Journal Name:	<u>British Journal of Applied Science & Technology</u>
Manuscript Number:	Ms_BJAST_29608
Title of the Manuscript:	Groundwater Assessment and Aquifer Vulnerability Studies of Emure Ile, Southwestern Nigeria
Type of the Article

PART 1: Review Comments

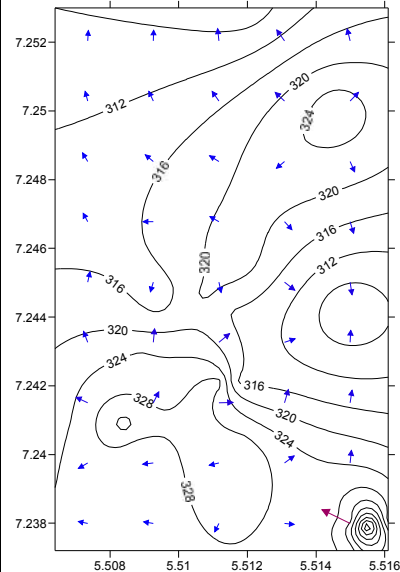
rise from Aboludo area, but the piezometric map tells different story, can you explain this? I got different results and interpretation from your data: **groundwater is contributing to sustain the river base flow**. See the northern area in the attached figure.
